Report to Planning and Environment Committee

Subject: 1154 Hamilton Road

City File: Z-9569 Ward 1 Public Participation Meeting

Date: March 27, 2023

Figure 5. Conceptual Site Plan

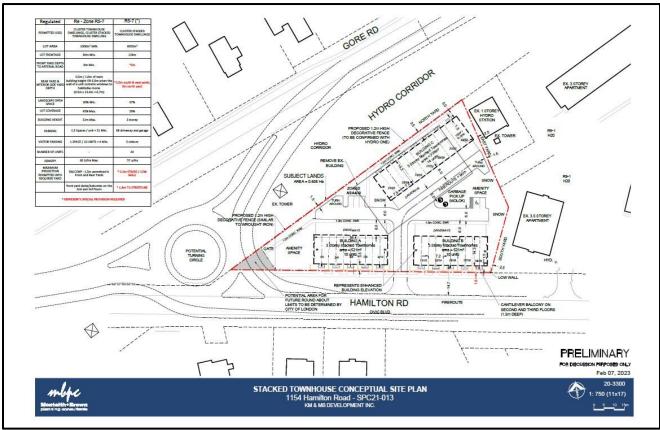
Lastly, City Staff noted that the Hamilton Road and Gore Road Environmental Assessment has not yet been finished, and therefore, the roundabout shown on the site concept drawing does not reflect the footprint of the proposed roundabout, should the roundabout become the preferred option. Notwithstanding that the roundabout was taken into consideration when designing the site concept, it is noted that changes to the site design and layout may be required during the review of the Site Plan application.

- Remove 4 parking spaces between Building B and C and provide a more substantial and usable amenity space.
- The turning radius for the end-unit parking space in Building A might be impeded by the proposed fence. Consider reducing one unit to provide adequate space, while increasing the amenity area.

- Pedestrian connections are required throughout the site. The sidewalk coming in off of Hamilton Road ends requiring pedestrians to walk along the road to meet the next sidewalk for Building C units. See attached red line drawing for pedestrian connection requirements.

- Where a driveway abuts a sidewalk, a minimum driveway length of 6.0m is to be maintained to accommodate any vehicle overhang.
- Sidewalks abutting the barrier-free parking stalls are to be a minimum of 2.1 metres to accommodate any vehicle overhang.

- The applicant is encouraged to relocate 2 of the visitor parking stalls to the north portion of the site to split up some of the visitor parking stalls and provide a larger amenity space.

- As indicated on the red-line drawing, the area in blue is to have wrought-iron fencing (or similar fencing type) with pedestrian connections and a gate to access the sidewalk connections at Hamilton and Gore Road.

- Along the Hydro One Corridor and around the rest of the site, a board-onboard fence is preferred.
- Remove the spacing in between the driveways and provide one continuous driveway space. Typically, the small spaces are used for parking and no landscaping would survive.

- i) Provide pedestrian connections throughout the site and wrought-iron fencing (or similar fencing type) and a gate along the area nearest the Hamilton Road and Gore Road intersection to access the sidewalk connections at the intersection.

- ii) Provide a minimum driveway length of 6.0 metres where a driveway abuts a sidewalk, and a minimum of 2.1 metres where a barrier-free parking stall abuts a sidewalk.

- iii) Consider alterations to current parking space configurations to provide a more substantial and usable amenity space and better screen any parking exposed to the public street.

Figure 11: Site Plan denoting the two encroachment special provisions.

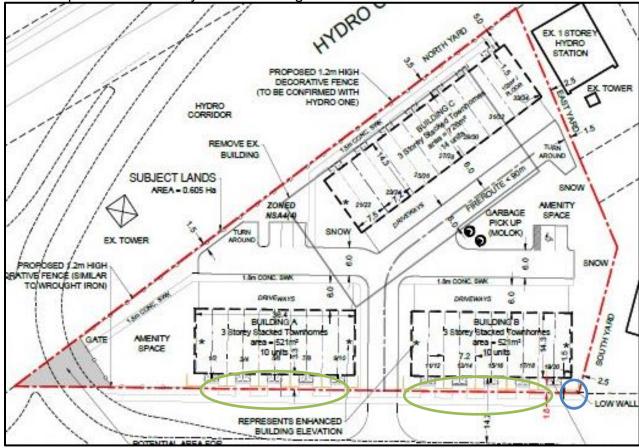
A maximum encroachment of 0.3 metres to the lot line for a non-structural architectural feature and a maximum encroachment for a balcony into the front yard of 1.8 metres to the lot line

The intent of encroachment regulations is to ensure that there are no structural encroachments or overhangs which would impact on adjacent properties, and that stormwater runoff does not adversely affect the abutting lands. In this case, the increased encroachment for a non-structural feature (circled in blue) is for the purpose of providing a low wall at the corner of the front yard and south interior side yard, while the increased encroachment for the balconies (circled in green) will facilitate the private amenity of units. Staff are of the opinion that the low wall and balconies are appropriately situated for the design of the site and for the benefit of residents and are not anticipated to adversely affect abutting lands.

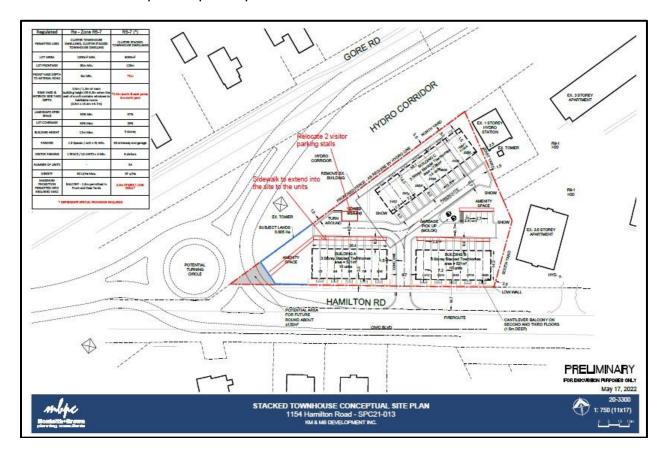
• Detailed comments regarding access design and location will be made through the site plan process.
